IMPROVEMENT PERMIT for a RESIDENTIAL ON-SITE WASTEWATER TREATMENT & DISPOSAL SYSTEM

GWS Septic System Design Review

RE: Request for an Improvement Permit for Lot 15 off of Sample Road.
MCHD File #6753B

SEPTIC SYSTEM DESIGN REVIEW WORKSHEET

Scale: 1 inch equals 50 feet	S&ME	Faison-Sample Road, LLC	FIGURE
Drawn by: JBP		Lot 15	1
Reviewed by: Jeremy P. Michelone, RS		Mecklenburg County, NC	
Date: March, 2007	ENVIRONMENTAL SERVICES · ENGINEERING · TESTING	S&ME Project #1588-05-091

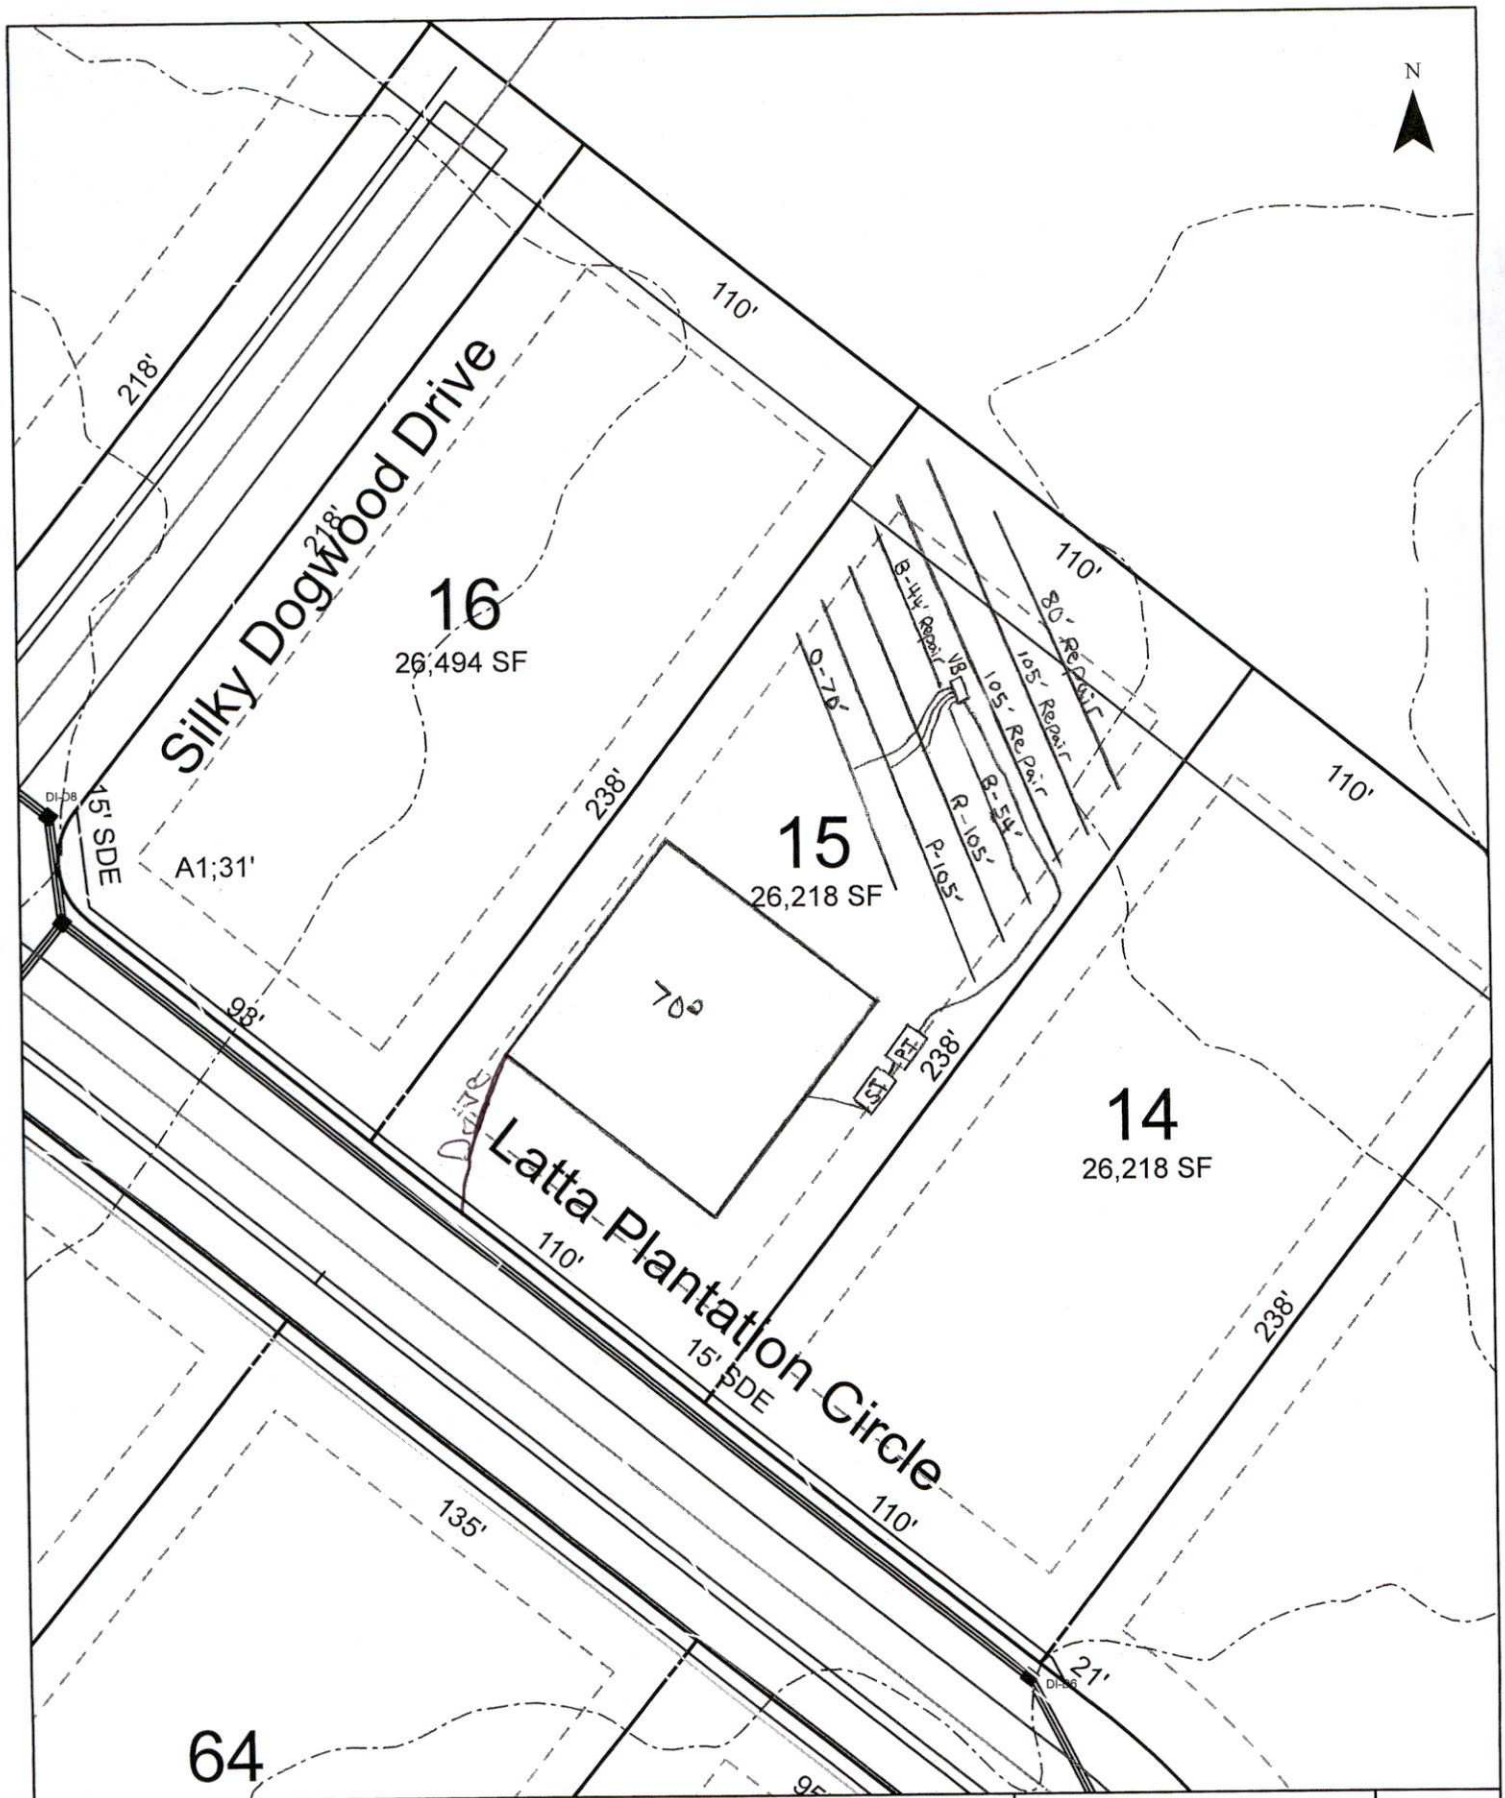
Please review the attached system sketch and design specifications for the Improvement Permit. Any additions or revisions you feel are necessary can be made on the Improvement Permit. Please call if you have questions or comments.
